Reviewed for Fire Code Compliance
Harnett COUNTY NORTH CAROLINA Roger Sullivan
11/25/2025 9:41:21 AM

Application for Plan Review

Name of Project: Flatwoods Middle School

Shop Drawing Review - General Note Comments:

SHEET No. FP-3 OF 13

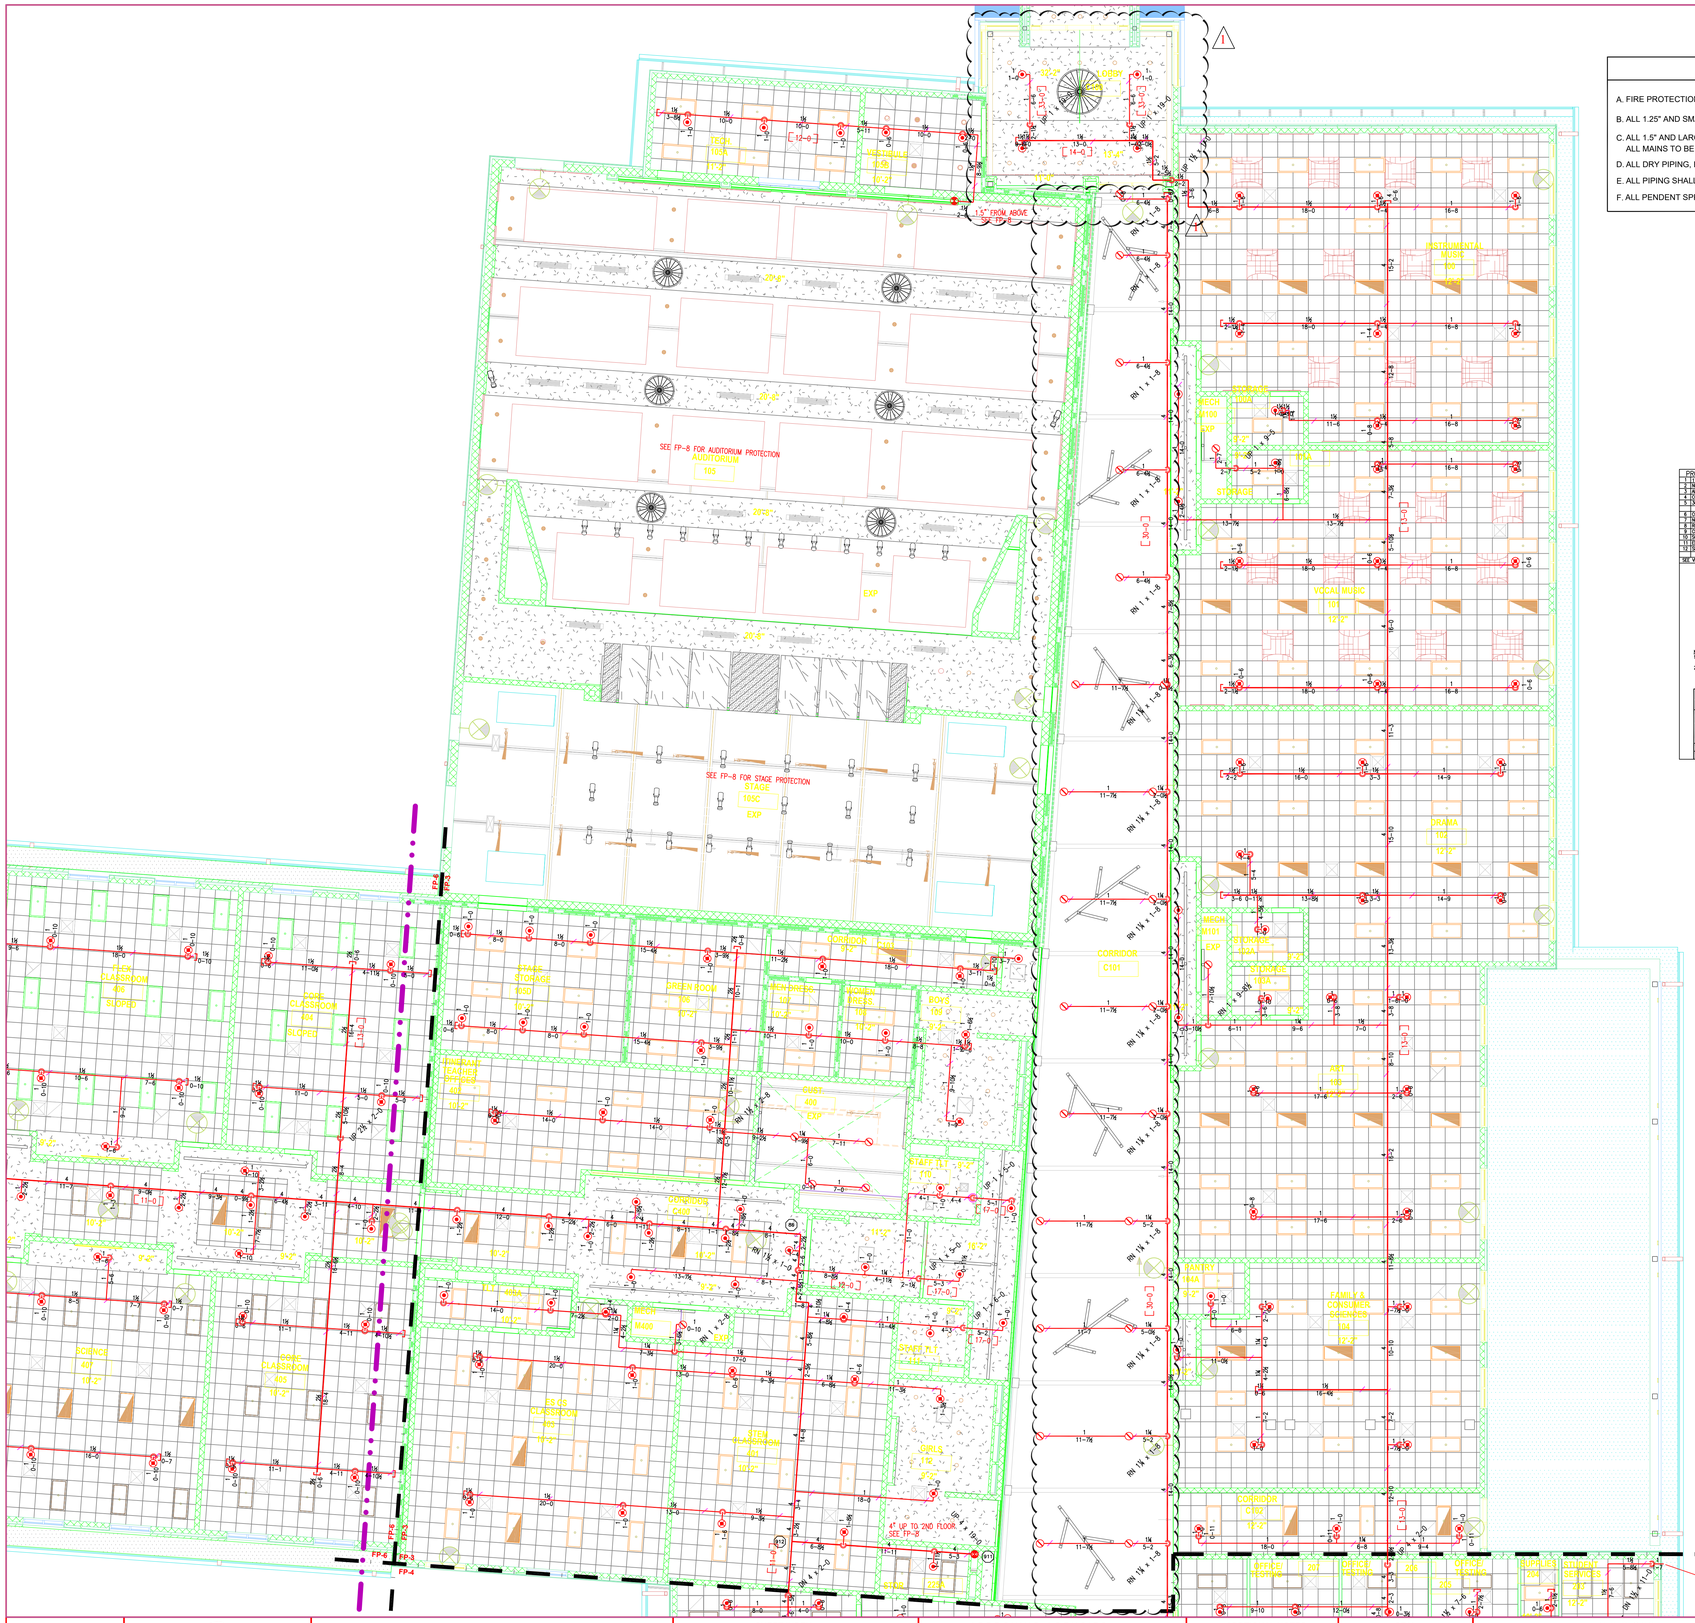
Sheet FP-3:

- Branch line has been relocated to run south and then pass through bulkhead
- The sprinkler shown outside of Lobby has been removed, it is not required.
- A 4-inch fire main has been added running down the East wall with the branch lines running between beams.

SHEET No. FP-8 OF 13

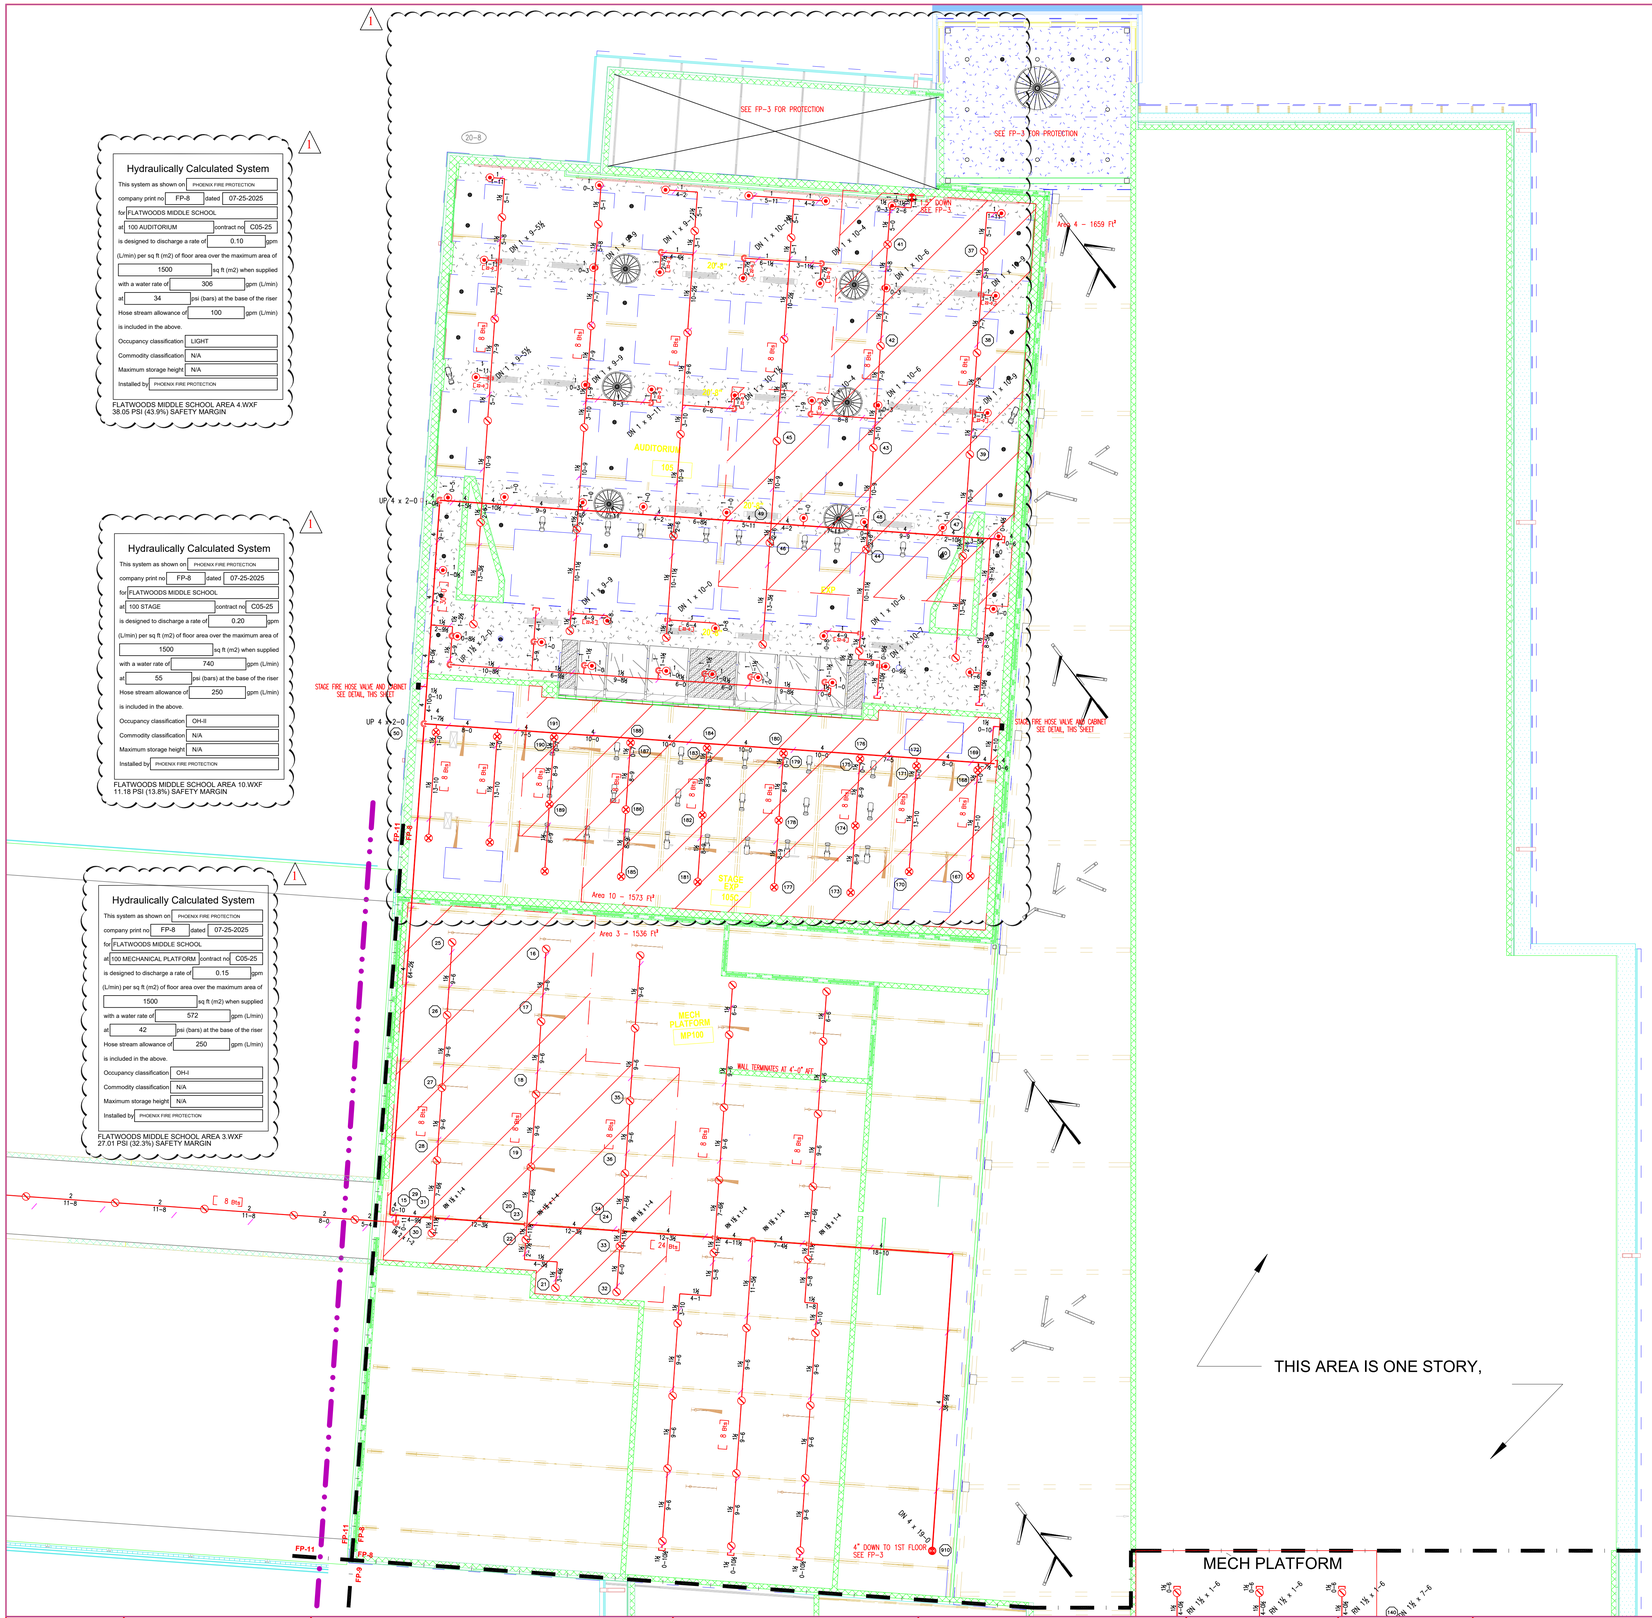
Sheet FP-8:

- Sprinkler line will be running down metal stud furr out as requested.
- Sprinklers cannot be placed between acoustic panels. The spacing would be too far apart and too far from deck above.
- Additional sprinklers to be added below ceiling bulkhead along north wall.

SHEET NO. FP-9 OF 13

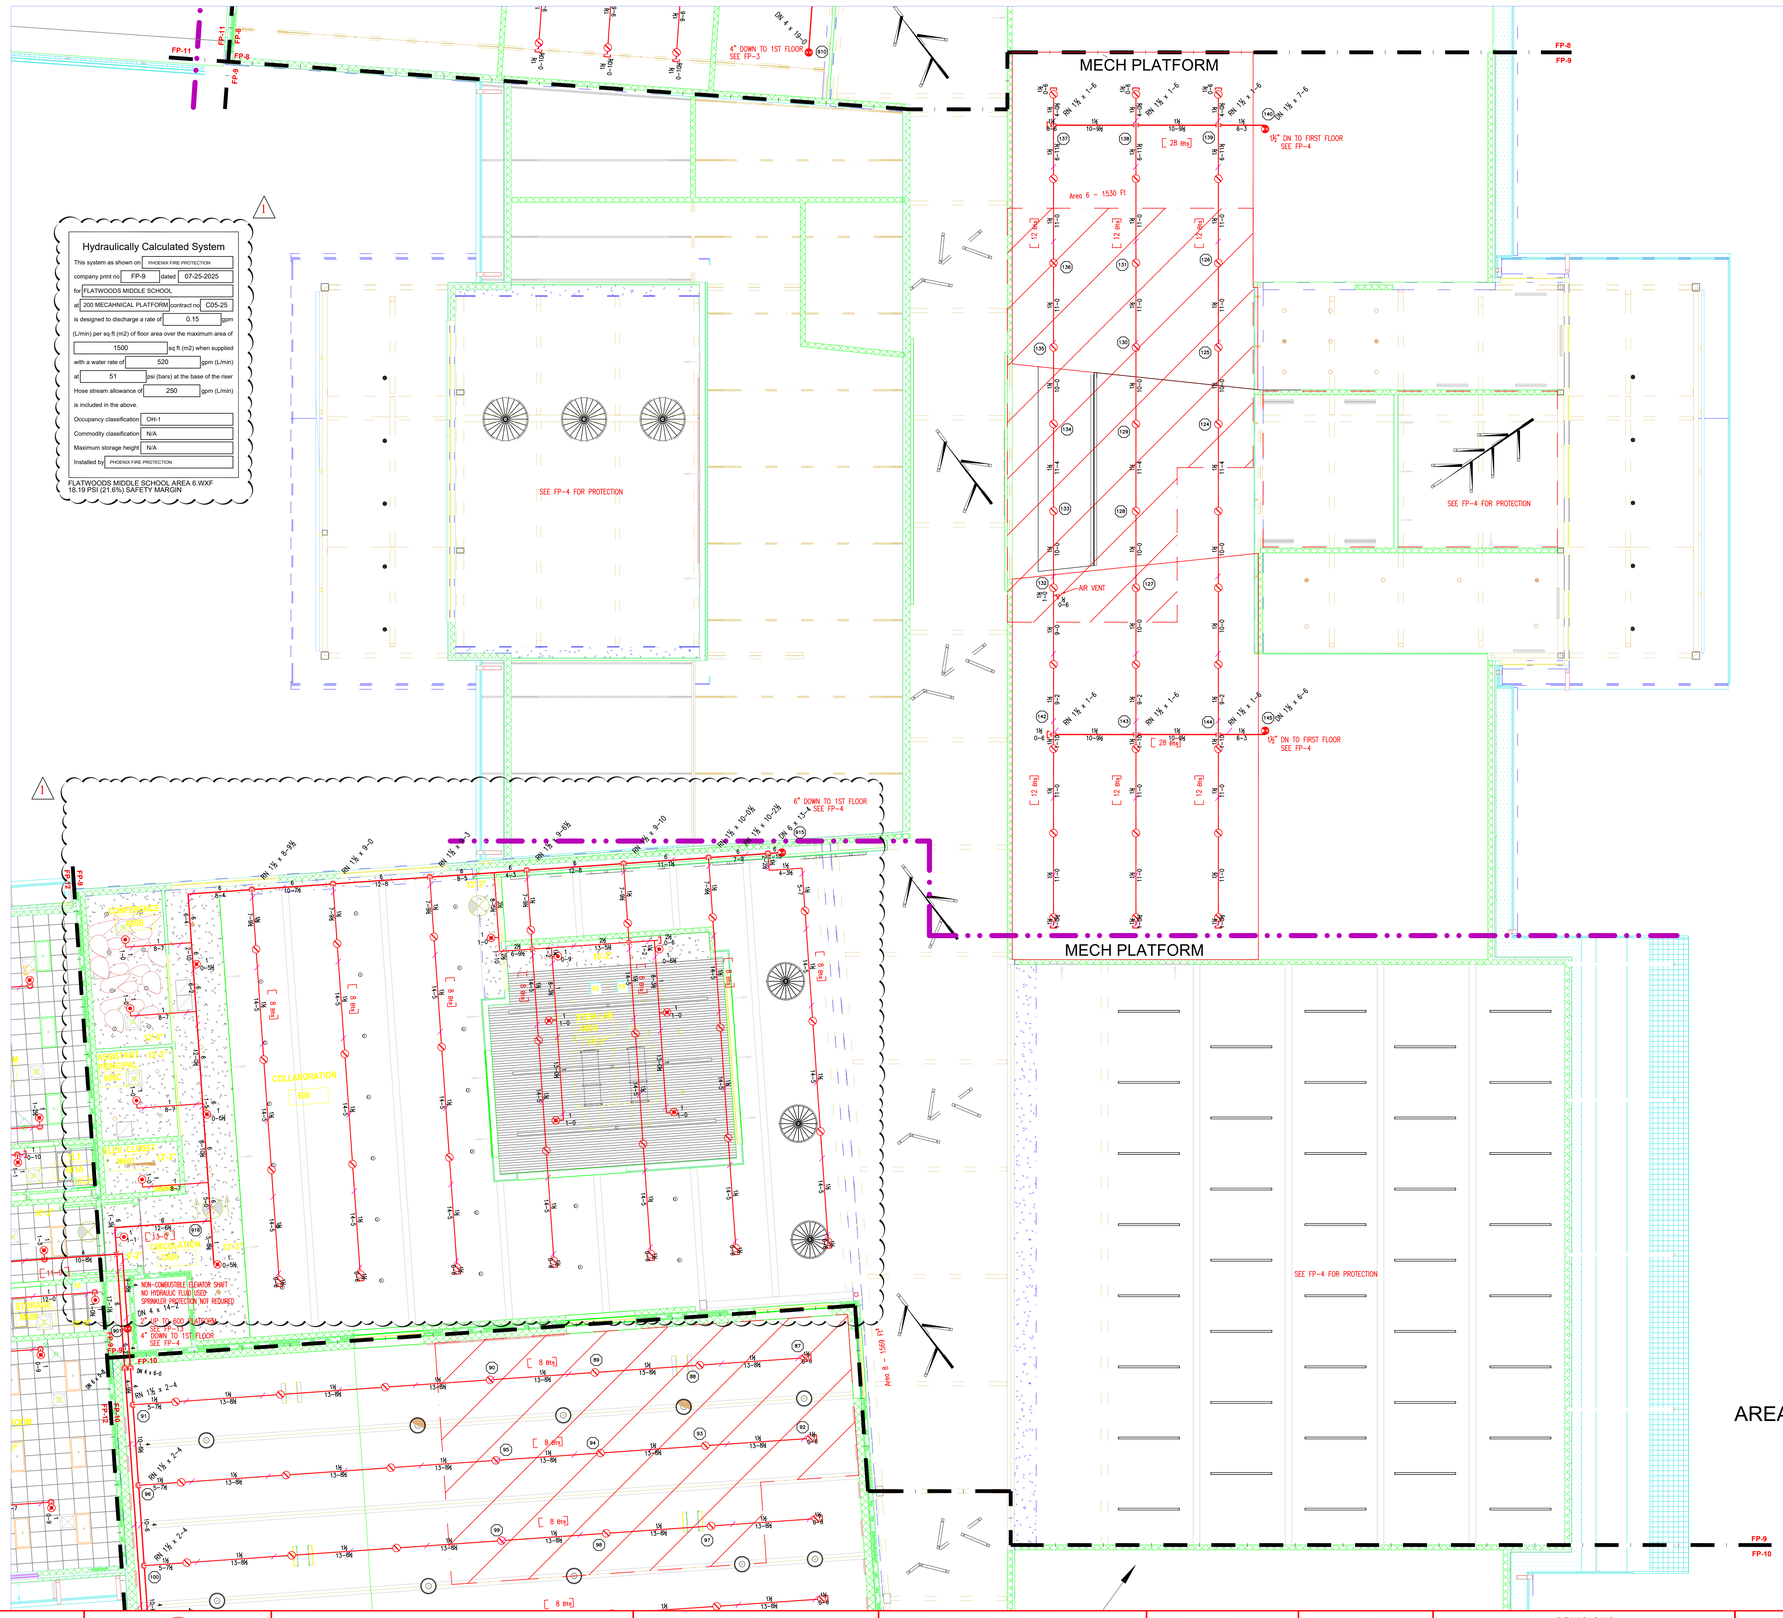
Sheet FP-9:

- Branch lines have been routed between beams.
- Revise piping layout to have a single line feed the Stem Lab.
